**STATE OF CONNECTICUT
CONNECTICUT SITING COUNCIL**

**Petition of BNE Energy Inc. for a
Declaratory Ruling for the Location,
Construction and Operation of a 3.2 MW
Wind Renewable Generating Project on
New Haven Road in Prospect,
Connecticut (“Wind Prospect”)**

Petition No. 980

**PETITIONER BNE ENERGY INC.’S INTERROGATORY RESPONSES
TO SAVE PROSPECT CORP’S SECOND SET OF INTERROGATORIES DATED
FEBRUARY 9, 2011**

EXHIBIT 1

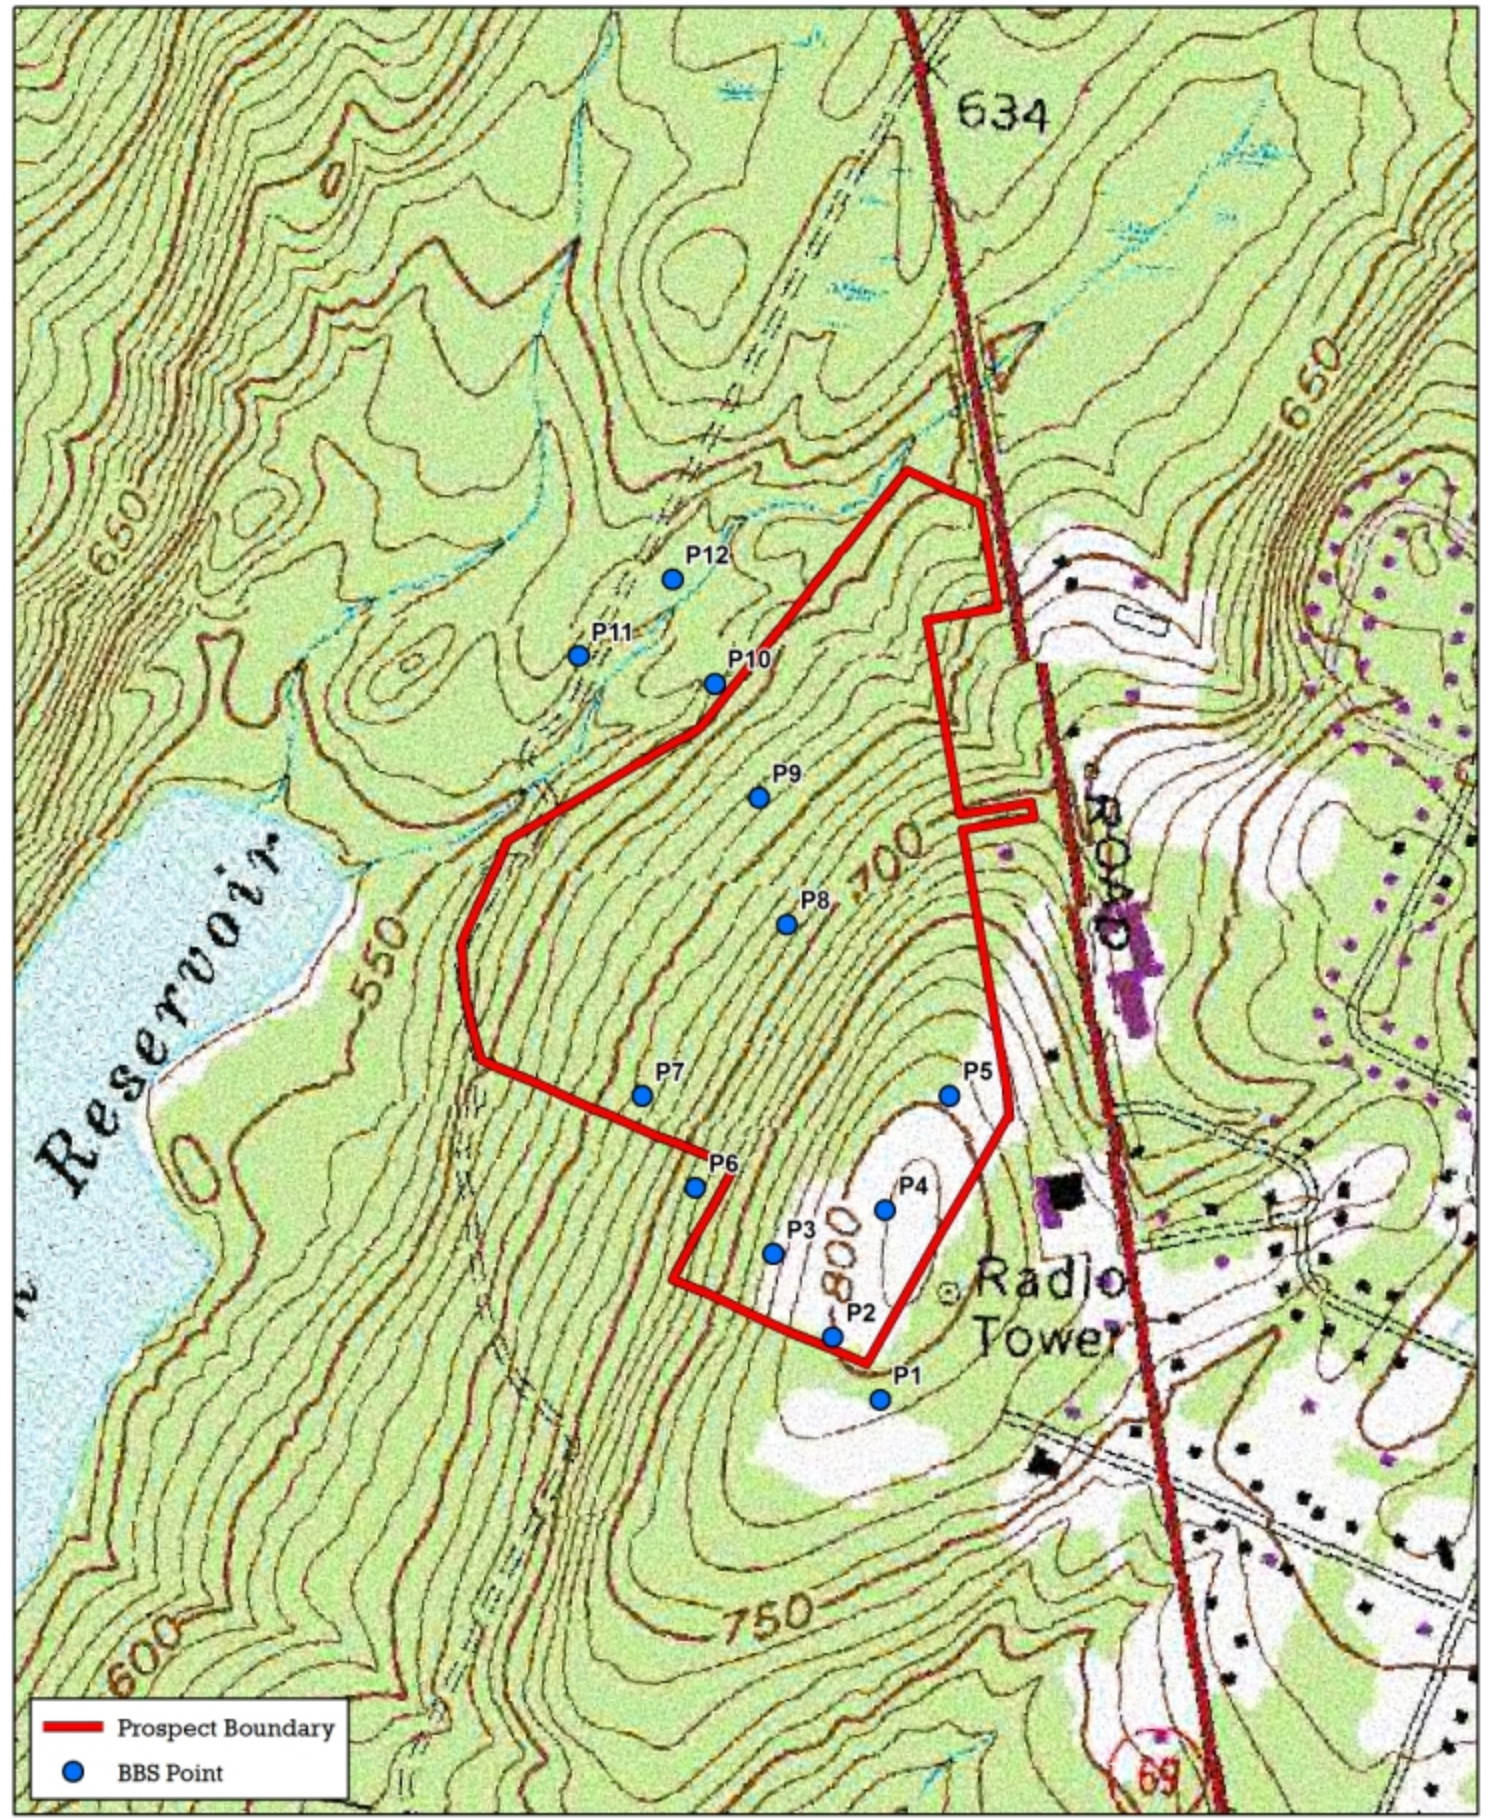
Q46. Please provide a more detailed map of the project site located at 178 New Haven Road(the "Site") showing the breeding bird survey points relative to the Site boundary and proposed activities on-site, and indicate why these point locations were chosen.

A46. See map attached hereto as Exhibit 1. Breeding bird survey point count locations were chosen along a roughly linear transect bisecting the Site, with the exception of a few points. Point locations were chosen in order to ensure good spatial coverage of the Site, ensure proposed turbine locations were sampled and ensure that representative land cover types present at the Site were sampled. Major bird habitat types (e.g. grasslands and woodlands) were targeted. The linear transect and 5-minute survey design was selected based on West’s experience completing similar surveys, state and federal guidelines and present knowledge of field survey designs.
